# PlanGrid Task Report - Jul 15, 2025

Prepared by Michael McDonnell

Jul 15, 2025

**Sheet**  
M-101L

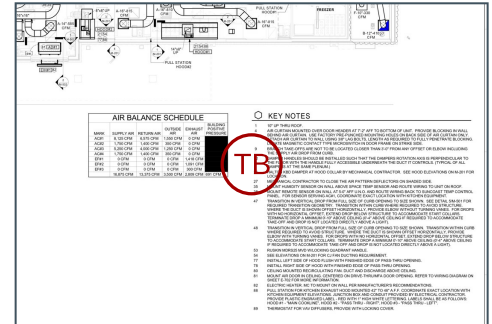
Dampers to be installed parallel to airflow. In horizontal runs, position damper on left or right at 9 or 3 o'clock. On vertical ducts position damper on bottom only (6 o'clock).

AC-1 Return dampers need to be reoriented. Note 12 pertains to all returns on that plenum. Note lacks clarity as plans show noted damper on bottom, but all others on plenum on the side. Recommend plans are reviewed.

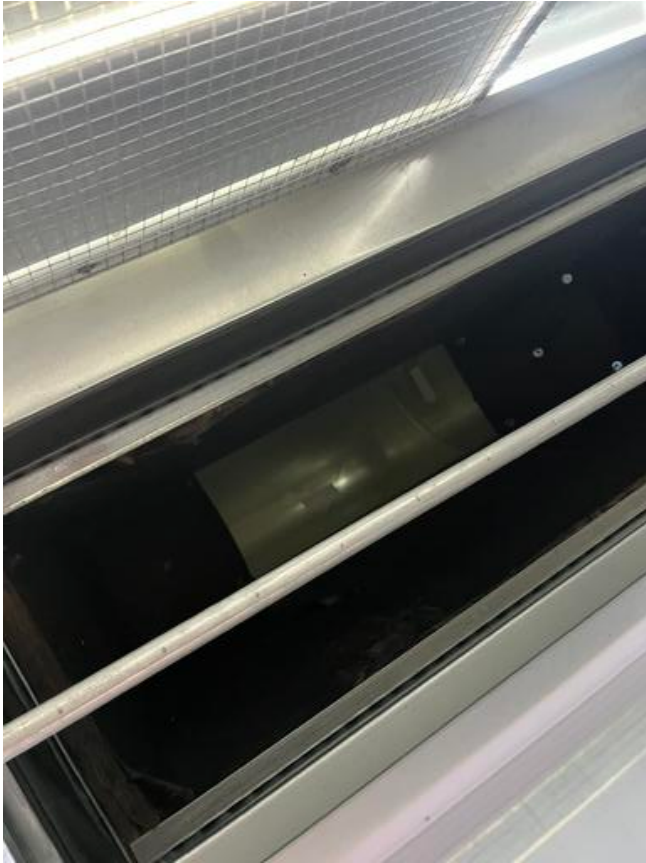
Duct is lined and restricts inside clear dimensions, remove and externally insulate. Only restroom rectangular duct is to be lined.

On all AC units, both the Supply and Return Drops are internally lined and externally insulated. Remove internal liner.

1 SAG/RAG/GRILLE TAKE-OFF - LARGE  
NOT TO SCALE

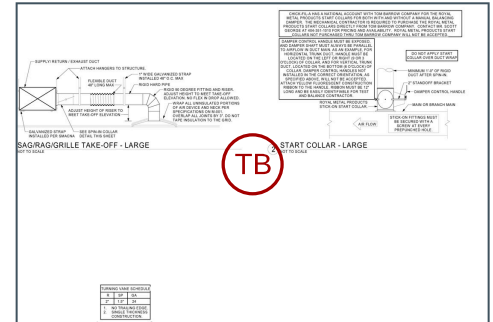
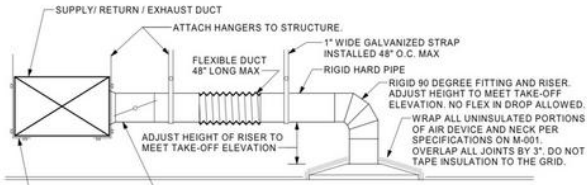
Installation in progress.  
Refer to Detail 1 on M-501.  
Flex must be used, but only in the horizontal. Rigid 90s and rigid pipe in vertical must connect to diffuser. Be sure flex connections are banded AND taped on inner core, and banded or taped on outer core.

**Sheet**  
MH-1.5

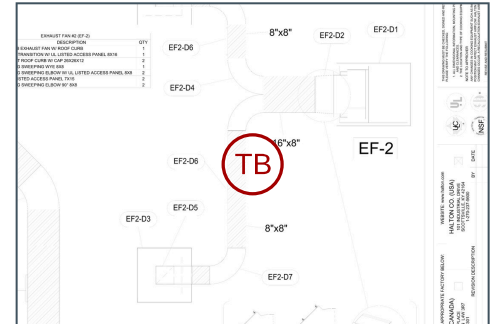
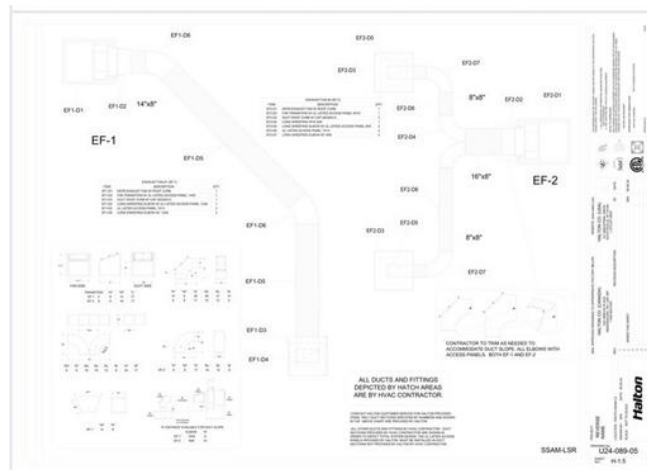
Installation in progress.  
 Refer to H-1.5 for cleanout door quantity, location, and type. Review Exhaust fan specs on M-501 for duct support stand specifications, G2 drip guard, etc.

Sheet  
M-701L

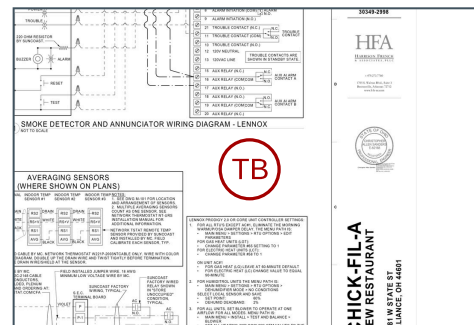
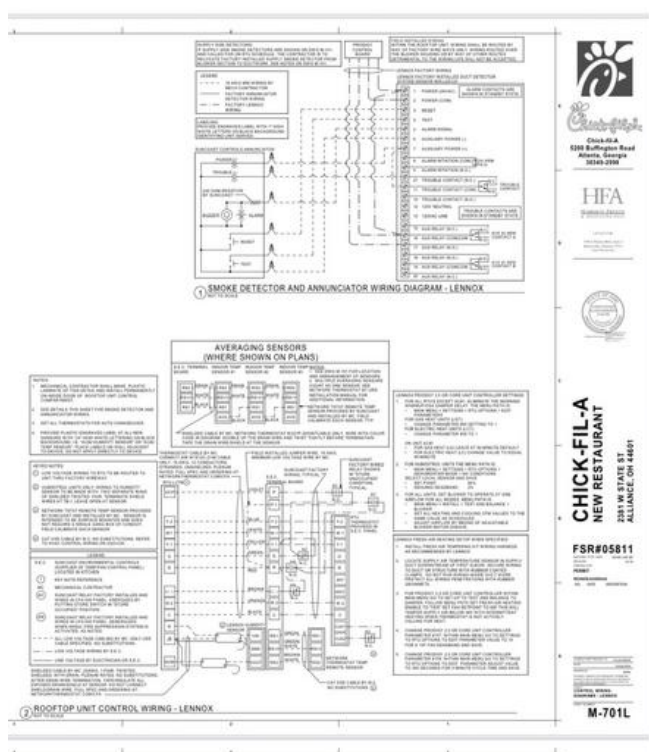
Control wiring in progress. Recommend M-701L is reviewed for control wiring specifications. Please note label requirements for annunciators and all sensors.

**5 CONDENSATE DRAIN PIPING**  
NOT TO SCALE

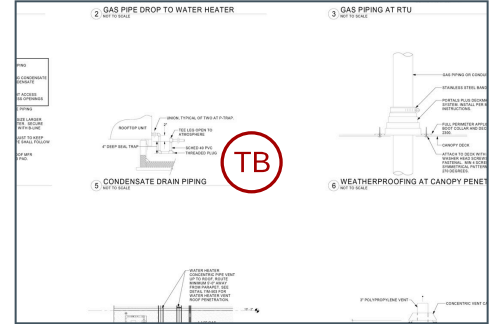
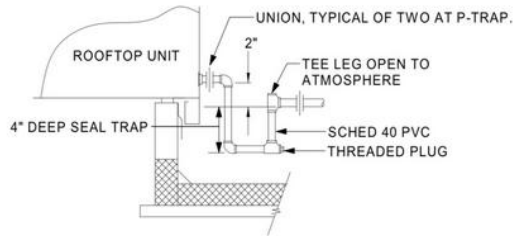
AC unit condensate drains are not yet installed. See detail 5 on M-503 for exact specifications.

**Sheet**  
M-701L

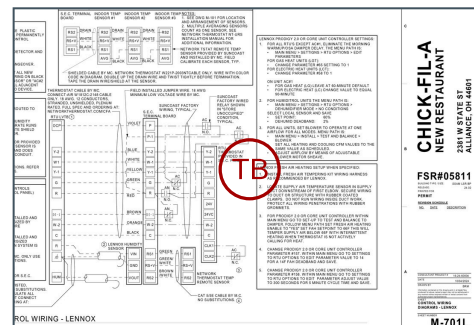
RTU Schedule indicates AC units are to have Fresh Air Tempering: Units with Fresh Air Tempering kits are to have the discharge sensor routed per specification into the discharge duct via wiring portal. The sensor should be installed after the first 90. For Lennox turn on FAH and set parameter #156 to 60 in Kitchen, 62 in Drive-Thru/Serving, & 63 in Dining/Play Area; then set parameters #157 to 14 & #158 to 300 on all.

See Notes on M-701L
